16 December 2019

Re: Bacchus Marsh Eastern Link Road planning study

Thank you for the opportunity to respond to the above project, which aims to identify a feasible route for an eastern bypass in Bacchus Marsh, in order to alleviate congestion caused by significant population growth.

Attachment 2: Proposed alternative routes as advised by John Hawker

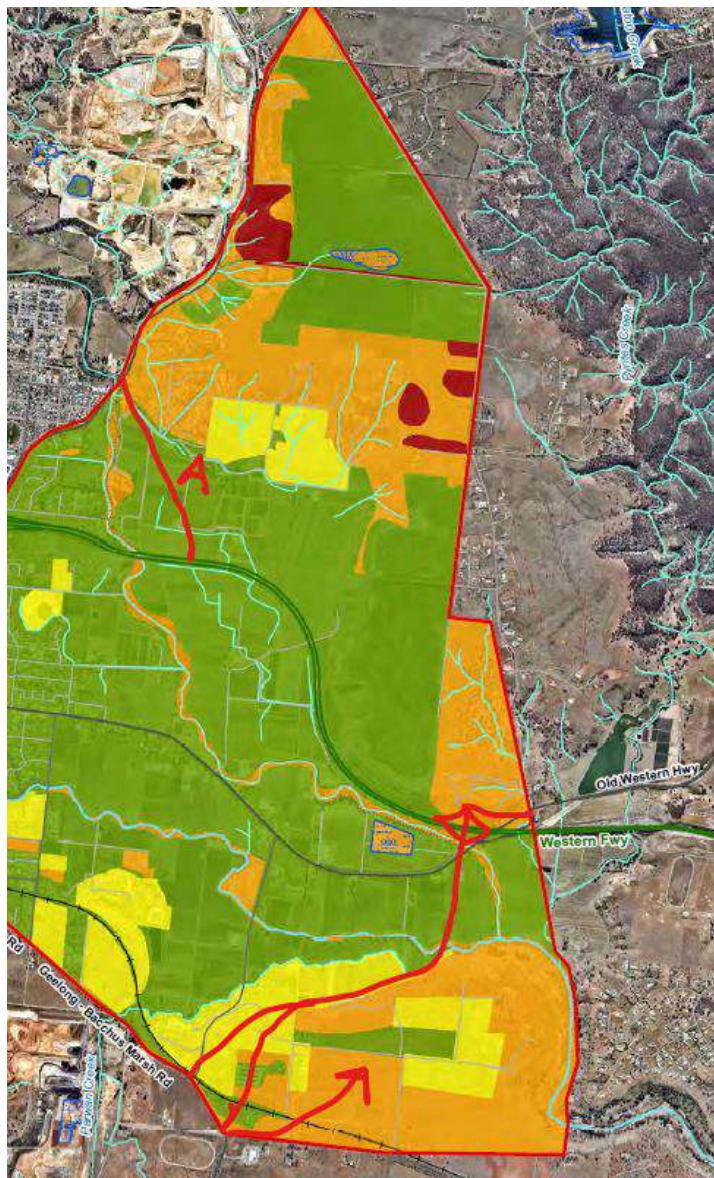
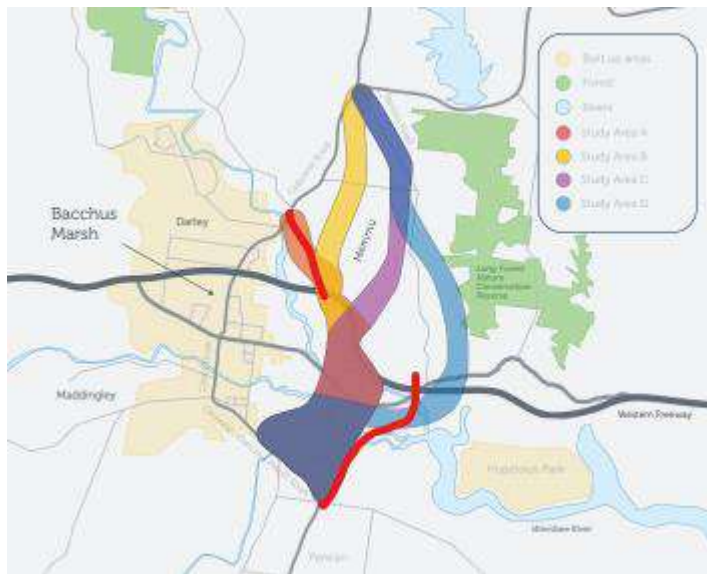
One such option is a route that incorporates a northern entrance point at Gisborne Road within Study Area A, connects to the Western Freeway, and has a southern exit off the freeway within Study Area D. This route option maximises use of the existing freeway, avoids

areas of high and very high ecological sensitivity, and does not affect the Avenue of Honour.² This route is less direct than Study Area A alone, but significantly shorter than Study Area D. Furthermore, this option would not impact on the irrigation district or the Merrimu Precinct Structure Plan. It is the opinion of the National Trust that such a design will have the least impact on the cultural landscape of the area.
